RE: Responses to Telephone Requests - August 29, 1996  
HRI Crownpoint Project

CHURCH-ROCK PROJECT  
RESTORATION FLOW SHEET

**CLARIFICATION AND ADDITIONAL INFORMATION REQUEST  
HYDRO RESOURCES, INC. IN-SITU LEACH URANIUM MINE  
CROWNPOINT, NEW MEXICO**

FIGURE 5-2

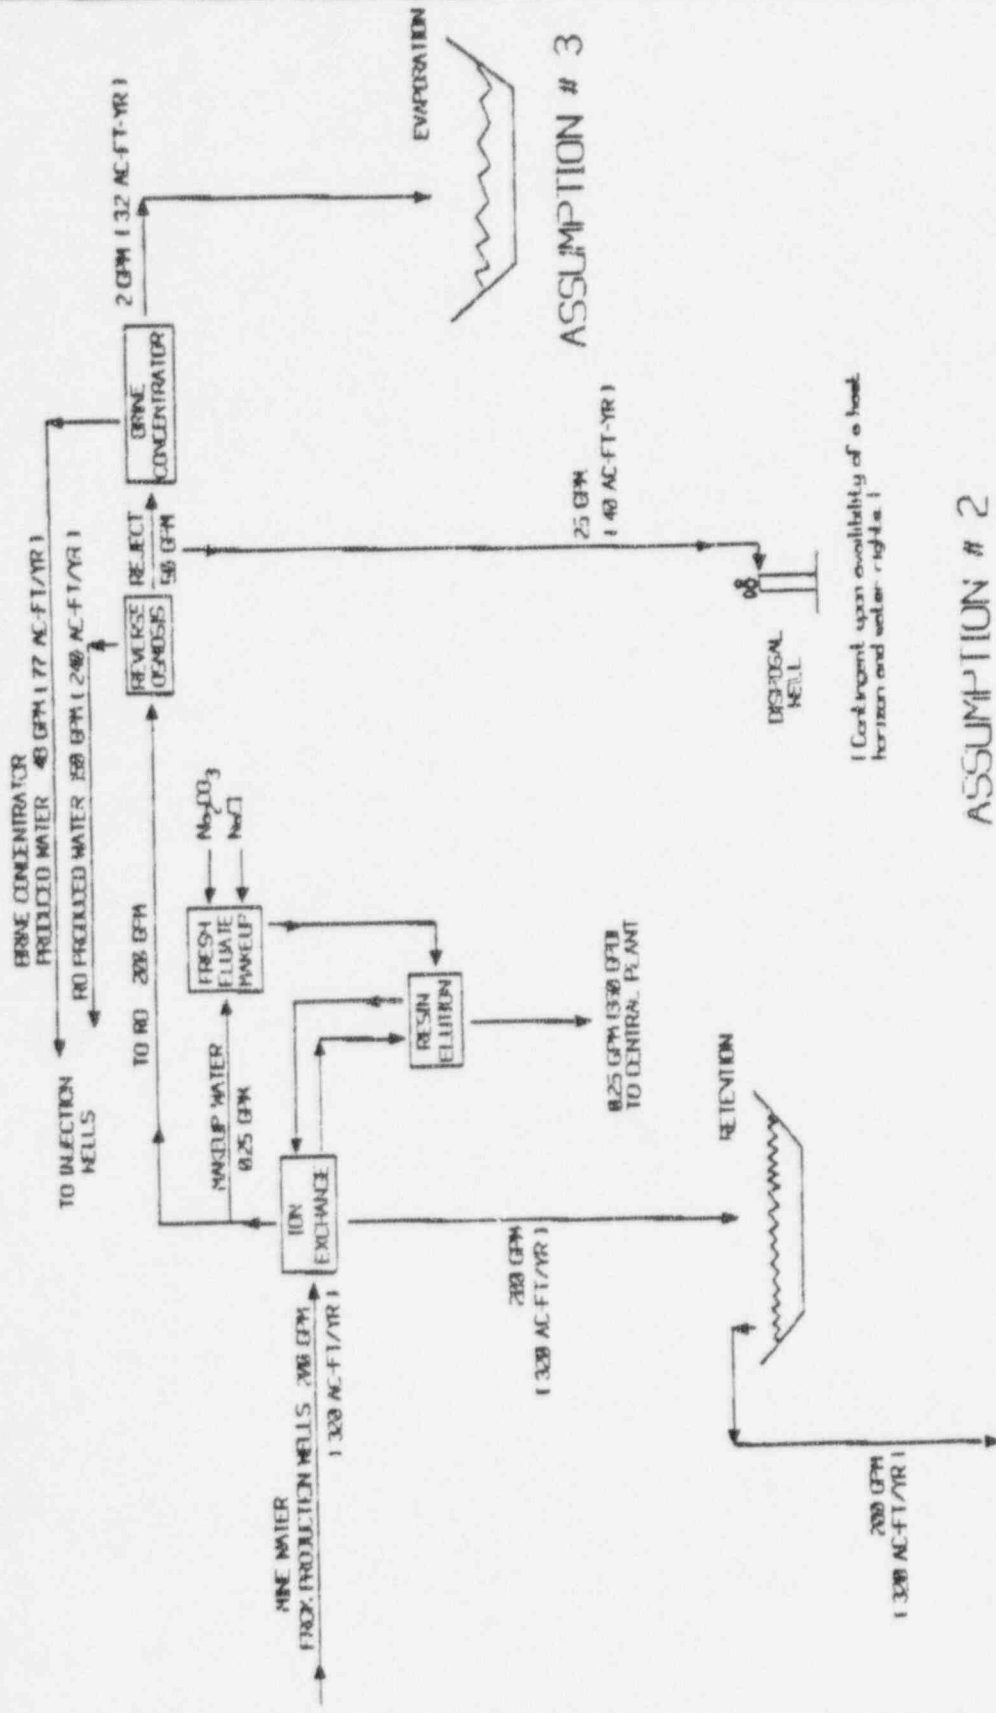
2. A revised version of Attachment Q2/59-3 is attached. Notations on the revised include:

- a. flow rates to land application
- b. contingencies for Assumption #1 and Assumption #2

LAND APPLICATION

(Contingent upon availability of Land Application permit and water rights)
